Memo on Sufficiency of GMD 5's Augmentation-Only Plan to Resolve Quivira Impairment

Kansas Department of Agriculture – Division of Water Resources

January 4, 2019

Figure 1 - Precipitation and streamflow - Rattlesnake Creek at Zenith 1974-2017.
 Source: streamflow from United States Geological Survey; precipitation from PRISM Climate Group, Oregon State University

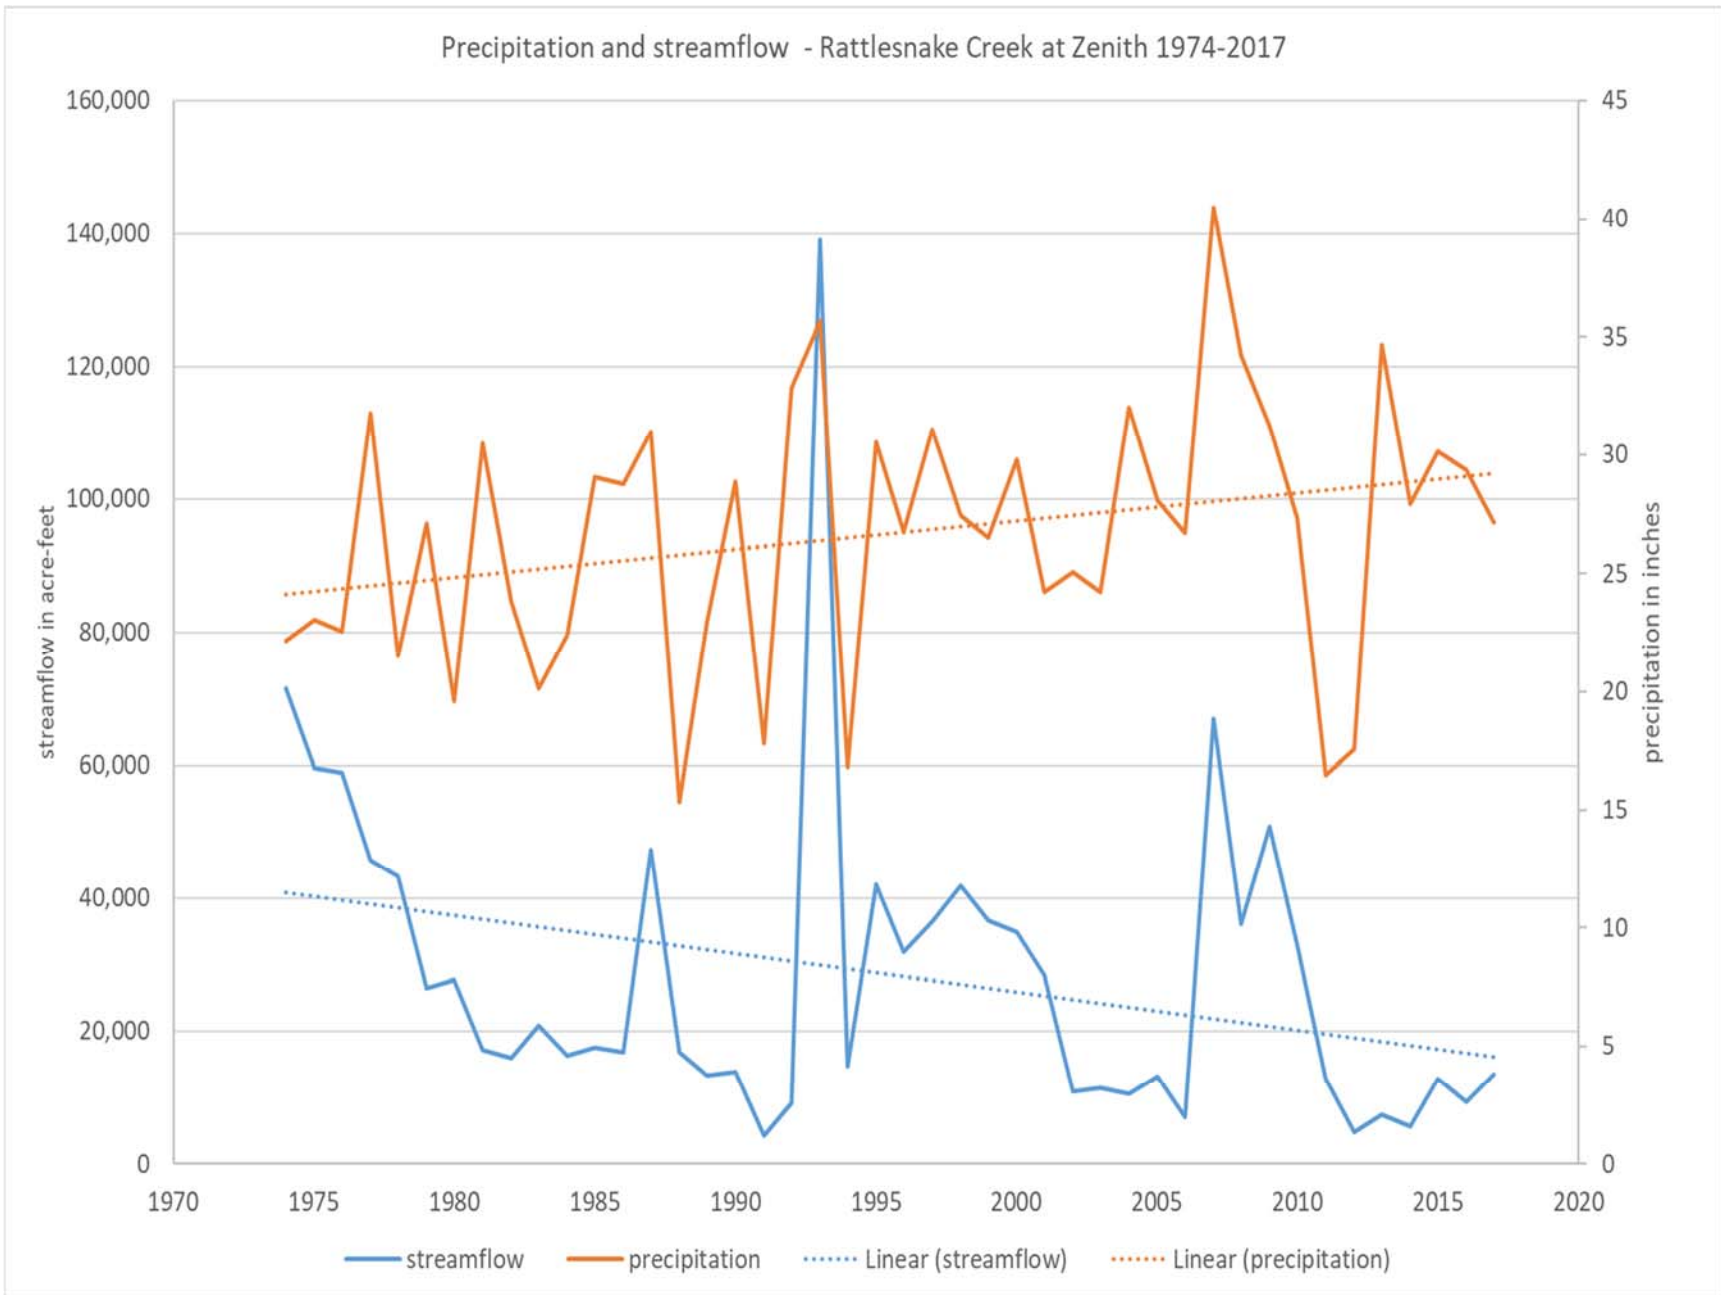
Historical streamflow analysis — KDA-DWR started with an analysis of historical streamflow, plotted with historical precipitation. The United States Geological Survey gage along the Rattlesnake Creek at Zenith shows that annual streamflow has been trending downward for decades, even though there is a long-term increase in precipitation in the area. (See Figure 1.) These trends illustrate the problem that KDA-DWR believes must be addressed as part of a long-term solution to the impairment; streamflow is being diminished by groundwater pumping, and the basin must take action towards stabilizing it. BGW modeling shows that the reductions in streamflow are due mostly to groundwater pumping.

Figure 2 - Rattlesnake Creek computed streamflow and component at Zenith
Source: Big Bend Groundwater District #5 Groundwater Model

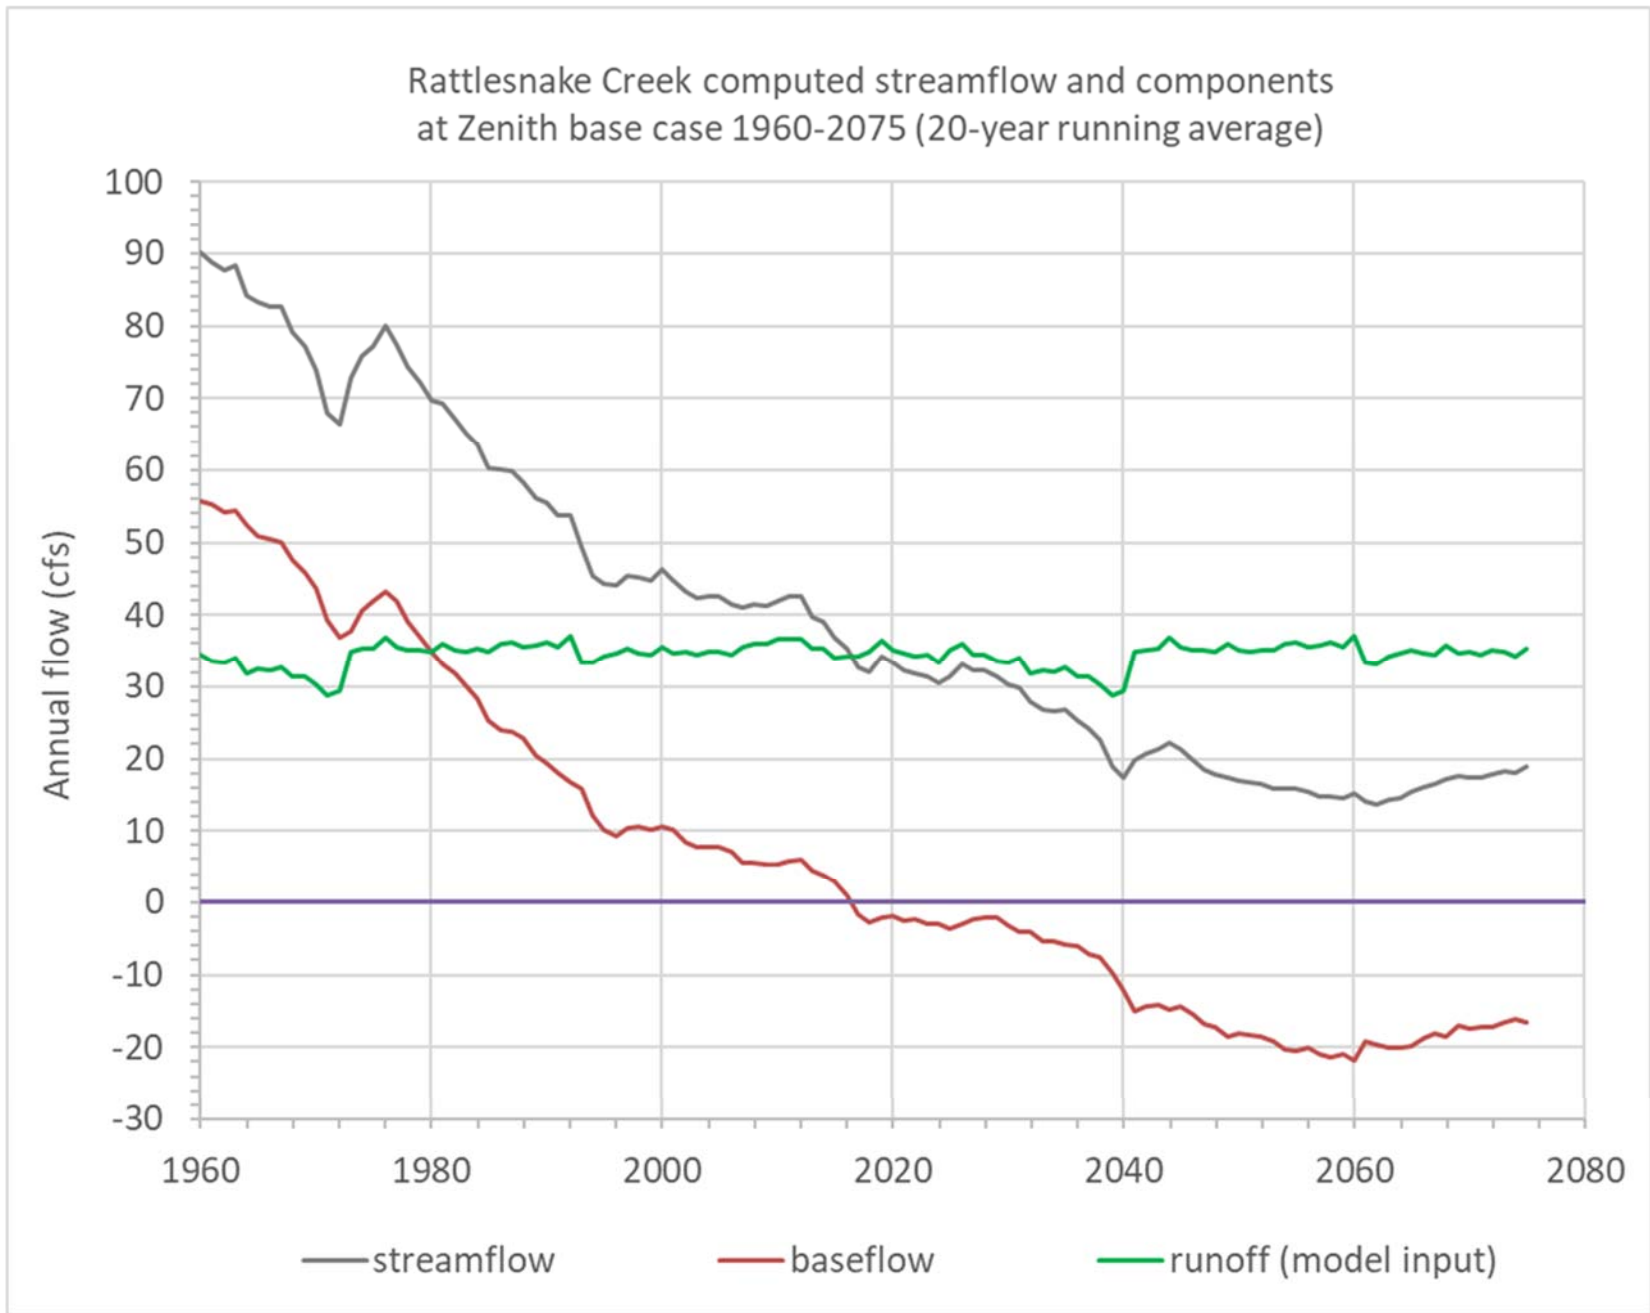
At a very high conceptual level, a groundwater model takes inputs (streamflow records, precipitation records, etc.) then runs calculations on them to produce outputs (future water levels, pumping impacts to streamflow, etc.) KDA-DWR separated streamflow from BGW's 2008-2075 Baseline A future projection into its baseflow and runoff components [4]. The runoff component of streamflow is an input to the model and varies with precipitation. As determined by BGW, runoff remains relatively constant over long periods of time. In contrast, the baseflow component of streamflow is an output calculated by the model and shows a significant downward trend. Historically, the Rattlesnake Creek above Zenith has gained streamflow from baseflow, but this has been in decline over time. Our analysis of BGW's future runs shows that baseflow transitions in the near future from a positive value (where the groundwater system adds to the streamflow) to a negative value indicating a losing stream. With no baseflow and increasing portions of the streamflow (runoff) captured by the aquifer system over time, total streamflow is significantly reduced. BGW projects that the system will stabilize at the point when Rattlesnake Creek has no baseflow and on average 18-20 cfs of the runoff that makes it to the stream soaks into the streambed and never makes it downstream. (See Figure 2.)

While BGW's average-conditions future analysis shows that streamflow eventually stabilizes at 13 cfs, at that point in time it is composed entirely of runoff. On a real-time, seasonal basis, the Refuge cannot

Figure 3 - Simulated impairment with no management actions

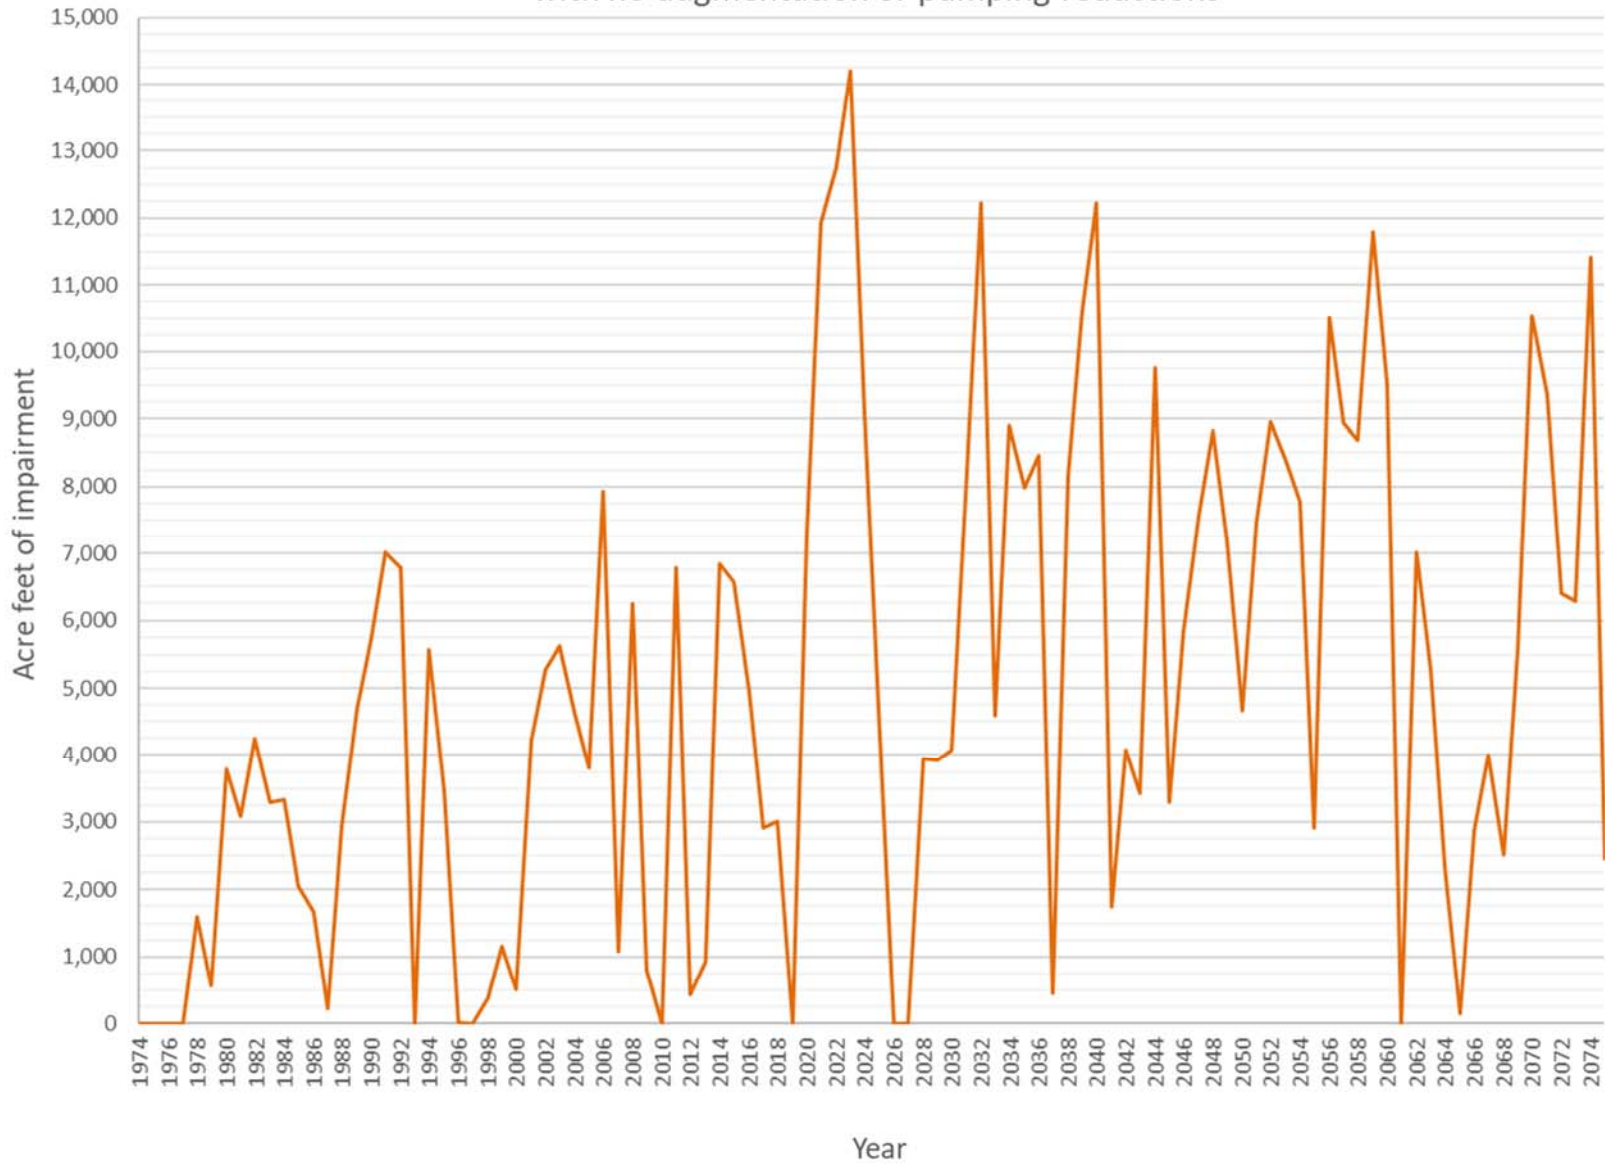
Figure 3 shows KDA-DWR's impairment analysis applied to the historical record and continued through BGW's future projection 2008-2075. Even as precipitation increases through the future projection, the frequency and magnitude of impairment also increase: impairment of 8,000 acre-feet on a regular basis and going as high as 14,000 acre-feet. Figure 4 shows the same analysis as in Figure 3 but accounts for the mitigating effect of a 15 cfs augmentation project with no annual limit on its quantity. Impairment will continue to occur regularly and outside drought periods. Relying on the proposed augmentation project only will not provide the volume of water necessary to overcome the shortages caused by junior pumping to the Refuge's water right and will allow the impairment to become worse over time.

Figure 4 - Simulated impairment with augmentation available in 2020

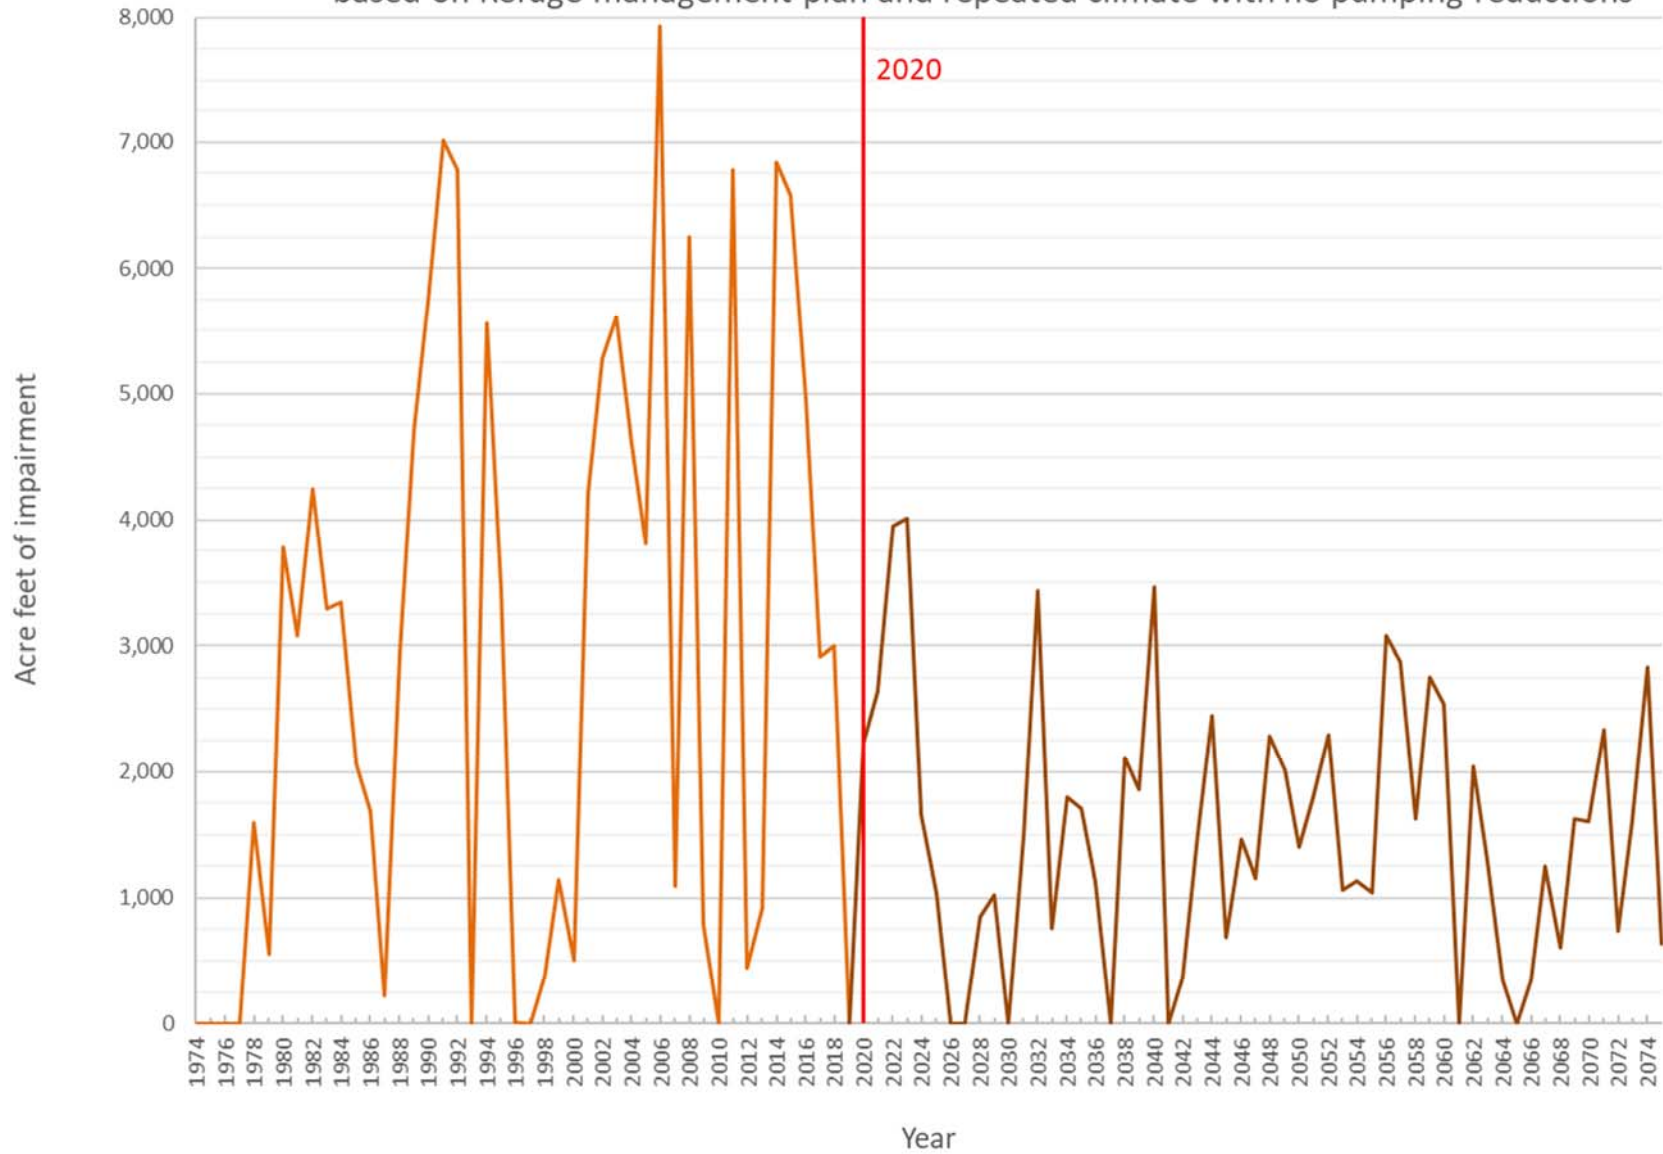
Conclusion: While GMD 5's proposed 15 cfs of augmentation would significantly reduce current and future impairment, if the current level of pumping is allowed to continue, augmentation only will not provide the 30 cfs needed to address the impairment in critical times when streamflow is being lost to the aquifer because of zero or negative baseflow, and there is no runoff available.
